UNITED STATES PATENT AND TRADEMARK OFFICE

APPLICATION NO.	FILING DATE	FIRST NAMED INVENTOR	ATTORNEY DOCKET NO.	CONFIRMATION NO.
10/534,250	03/09/2006	Hirofumi Akagi	4639-003	4964
22429	7590	07/02/2007	EXAMINER	
LOWE HAUPTMAN BERNER, LLP 1700 DIAGONAL ROAD SUITE 300 ALEXANDRIA, VA 22314				BERHANE, ADOLF D
ART UNIT		PAPER NUMBER		
		2838		
MAIL DATE		DELIVERY MODE		
		07/02/2007 PAPER

Office Action Summary	Application No.	Applicant(s)
	10/534,250	AKAGI, HIROFUMI
	Examiner	Art Unit
	Adolf Berhane	2838

FIG. 8

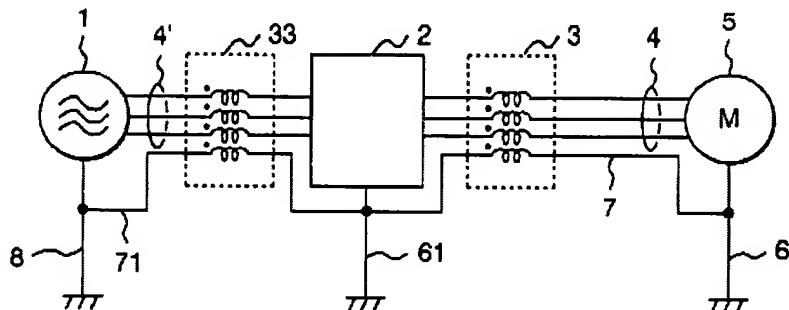
5. Applicant's arguments filed 2/14/07 have been fully considered but they are not persuasive. In response to Applicant's argument that Figs. 9-13 of Ayano, line 7 does not connect a neutral point of motor 5 to a reference potential point. The neutral point of motor 5 is at element 6, which, as illustrated in Figs. 9-13 of Ayano, is not connected by line 7 to the reference potential point. Applicant's attention is directed to Fig. 8 shown below which clearly shows the neutral point of motor 5 elements 6, which is connected to line 7.

FIG. 11

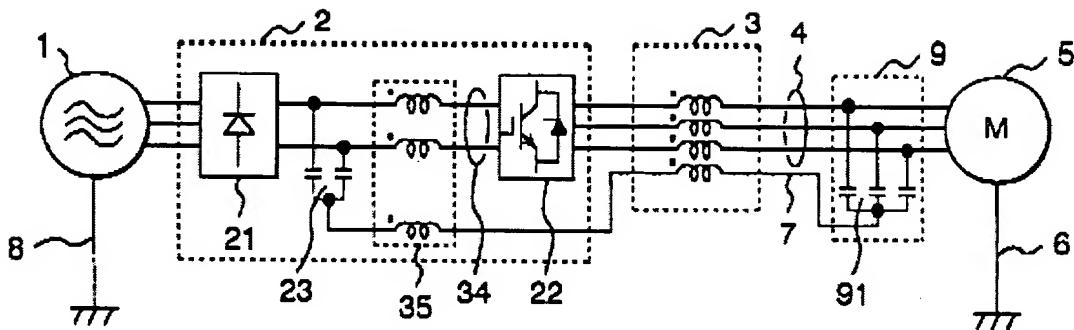
Applicant further argues that the common mode choke is not connected to the direct current voltage input. Applicant's attention is directed to Fig. 11, which shows common

mode choke (35) connected to the input of the direct current voltage.
